# GE RESPONSES TO NRC QUESTIONS FOR PILGRIM SHROUD REPAIR

March 1995

## Pilgrim Core Shroud Repair NRC Questions and Responses

Figure 13-1. Flow Blockage In The Upper Downcomer Area

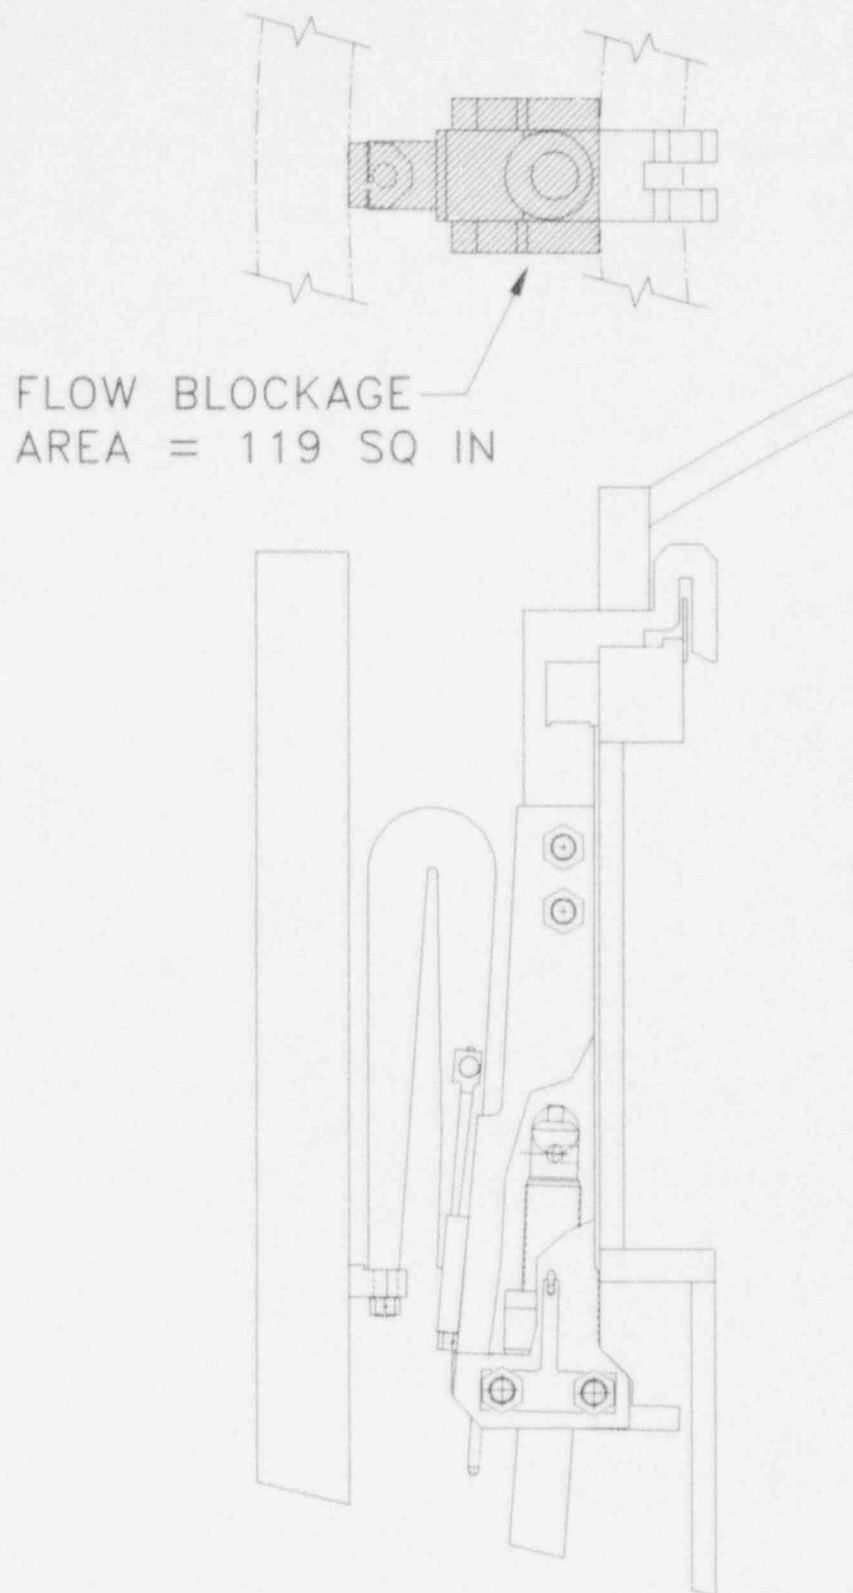
*Provide the analysis of the downcomer flow characteristics with the four stabilizers installed. Specifically, address the available flow area in the annulus, the associated pressure drop, and the impact on reactor coolant level, recirculation flow, and ECCS performance.*

The smallest vessel-to-shroud annulus plan area (downcomer flow area) is above the top guide ring area of the shroud (44.5 in. above the jet pump suction nozzle inlet) as shown in figure 13-1. This flow area, based on the as-built vessel diameter\*, and the area of items which block this annulus is summarized in the table below. Based on this table, the four added upper stabilizer springs and their supports block about 5 percent of pre-repair minimum downcomer area. This blockage applies only to the short vertical distance corresponding to the length of the upper stabilizer springs and their supports, located between welds H1 and H2. The additional horizontal flow blockage from shroud stabilizer hardware at other elevations in the shroud-to-vessel annulus will be less than this area. The impact of the additional flow blockage on the recirculation system loop hydraulic resistance, loop pressure drop, and the coolant flow rate is estimated to be negligible.

FIGURE 17-1  
UPPER STABILIZER ASSY

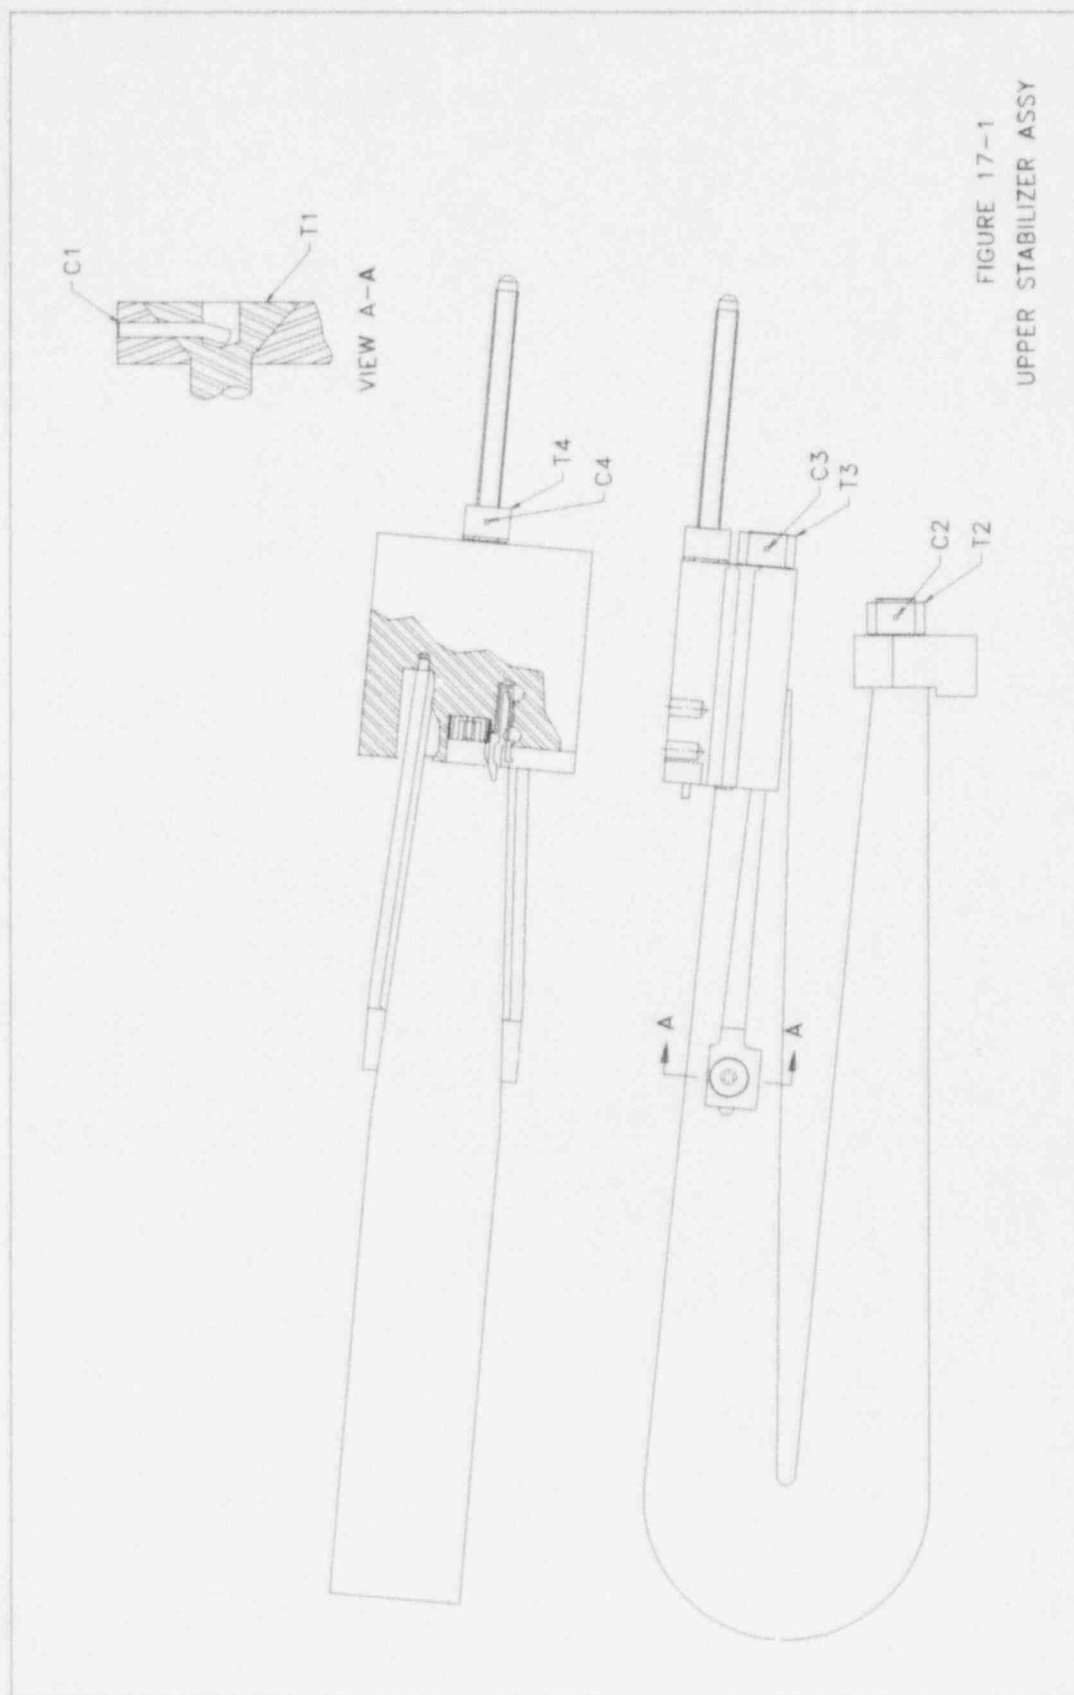
*Please identify all the threaded areas and locations of crevices and stress concentration in each component of the core shroud repair assemblies. In the planning of inservice inspection, those areas should be emphasized for inspection because these areas are most*

*susceptible to stress corrosion cracking. Please provide this information in tables and supplement it with sketches.*

All threaded and crevice areas in the stabilizer hardware are identified in the table below and in the six accompanying figures. One might debate the question of whether any threaded member also creates a crevice, but as all threaded areas are identified these are not identified again as crevice areas. Areas identified as crevices all have some associated mechanical cold work, such as a deformed locking pin. All calculated stresses for steady state normal operation are less than 50 percent of the allowable; thus there are no areas where stress should influence inspection planning. There are no welds in any shroud stabilizer hardware, and no welding is allowed for the installation of this hardware. See also the response to questions 19 and 25 below.

| Figure Number | Part or Assembly Nomenclature   | Crevice & Threaded Area Identification<br><i>Tn = Threaded Area</i><br><i>Cn = Crevice Area</i> |
|---------------|---------------------------------|---|
| Figure 17-1   | Upper Stabilizer Assembly       | C1, T1<br>C2, T2<br>C3, T3<br>C4, T4  |

FIGURE 26-1  
RING ROTATION ABOUT TOE OF FILLET  
(NOT TO SCALE)

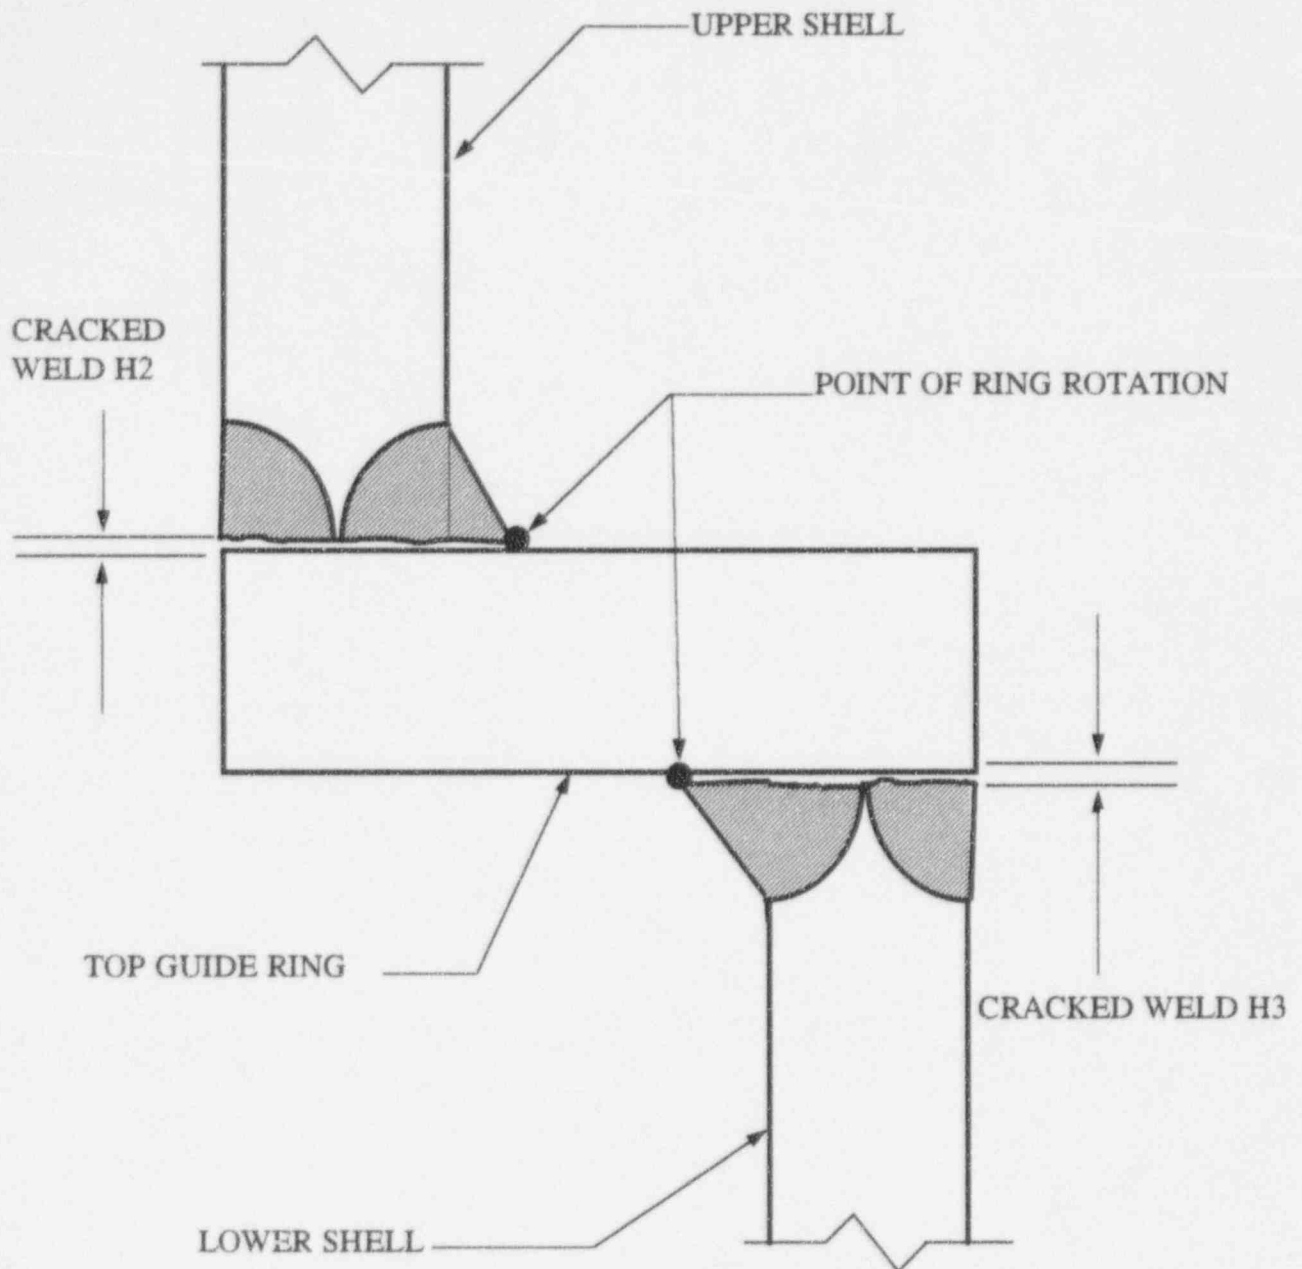
*If the credit for the fillet or any circumferential welds in the core shroud is taken in the design of the proposed repair to maintain the required preload, please discuss in detail and provide the justification regarding the measures you plan to take such as inspection to ensure the welds are, and remain, in the condition assumed in the analyses. Please also discuss the feasibility of measuring the preload during plant operation.*

While calculating the vertical stiffness of the shroud for gap calculation, two different methods of crack modeling were used. The first method assumed a through wall crack across the bottom of the fillet and the ring is assumed to rotate about the toe of the fillet, as shown in Figure 26-1. This configuration reduces the moment arm compared to the second method. The second method assumed a through wall crack at the top of the fillet, as shown in Figure 26-2. Consequently, the ring cross section had a higher moment of inertia, which results in a slightly higher stiffness compared to the first method. These two methods reasonably bound the possible H2 and H3 weld crack configurations. Based on these results, for Pilgrim, the first method (with the lower stiffness and thus more conservative) was used for stiffness calculation in the analysis. The analysis showed that there was no separation under normal conditions. Since the analysis is based on a through-wall cracking across the bottom of the fillet, the H2, H3, H7 and H8 welds do not have to be intact to make the shroud repair functional. It is, therefore, concluded that no inspection of these welds is required to maintain the preload. For details on preload measurement, see the response to Question No. 23.
